UNITED STATES PATENT AND TRADEMARK OFFICE

| APPLICATION NO. | FILING DATE | FIRST NAMED INVENTOR | ATTORNEY DOCKET NO. | CONFIRMATION NO. |
|-----------------|-------------|----------------------|---------------------|------------------|
| 10/697,843 | 10/30/2003 | Uwe Kraft | 0065-011 | 9290 |

Office Action Summary

DETAILED ACTION

coupling element for claim 22

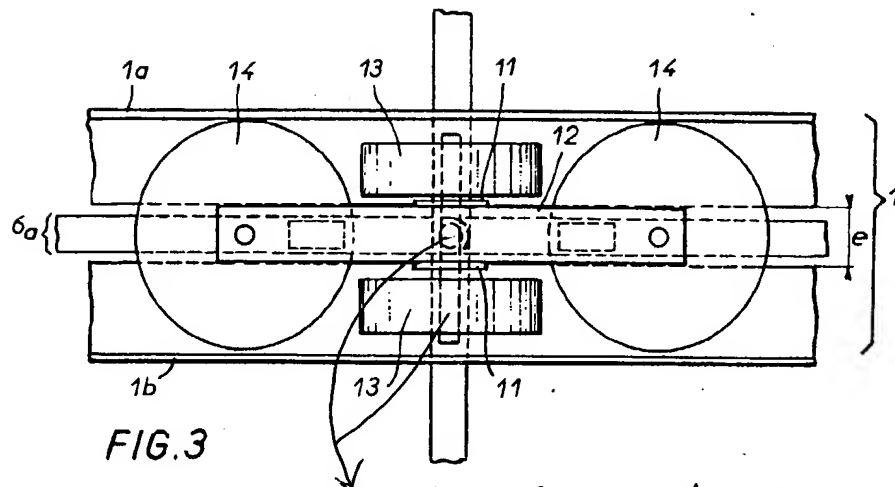
4. Claims 1-3, 5-8, 13, 17-26, 30 and 31 are rejected under 35 U.S.C. 102(b) as being anticipated by Hesnault (US 4,138,966) (Please see a more detail Figure 3 of Hesnault attached with the Office Action for further explanation for claim 22).

For claim 21, Hesnault further discloses the supporting structure comprises a first (1a) and a second rail (1b) in parallel with each other, and wherein the traveler comprises at least a first (13) and a second traveler part (13), with the first traveler part being moveably arranged on the first rail and the second traveler part being moveably arranged on the second rail (see Figure 3).

For claim 22, Hesnault further discloses the coupling element for connecting the first and parts (see attached Figure 3).
